PROJECT #: 19755 SIMPSON AVENUE

SUBJECT: PRE-APPLICATION

FROM: KAREN SWENSON, SENIOR PLANNER

DATE: SEPTEMBER 1, 2021 (UPDATED NOVEMBER 10, 2021)

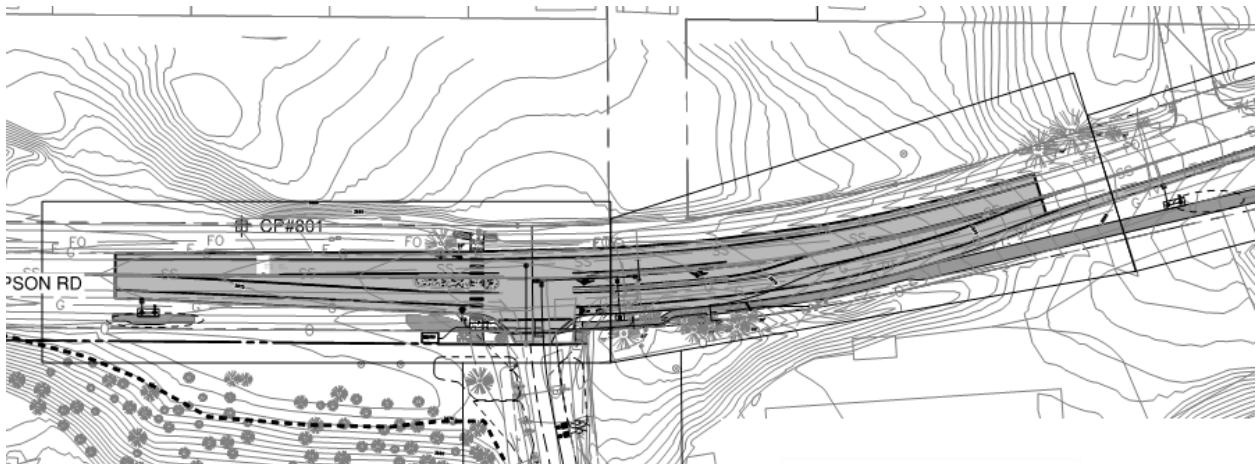
- a. The frontage was recently paved in the proximity of the OSU entrance on Simpson Avenue (see figure below). By the City's design standards, there is a 5-year moratorium on the asphalt requiring the entire "new" roadway to be repaved if cut. There are very few exceptions to this standard. If it is just road widening, the City might be able to work with you with saw cuts at the property line. If you are saw cutting for services or mains, this restoration requirements could be expensive for the development. For an affordable housing project, the City could consider cuts into the bike lane only to access a sewer manhole, but not the travel lane, without the need for full restoration. More information on the sites development might help to determine the need for restoration requirements.
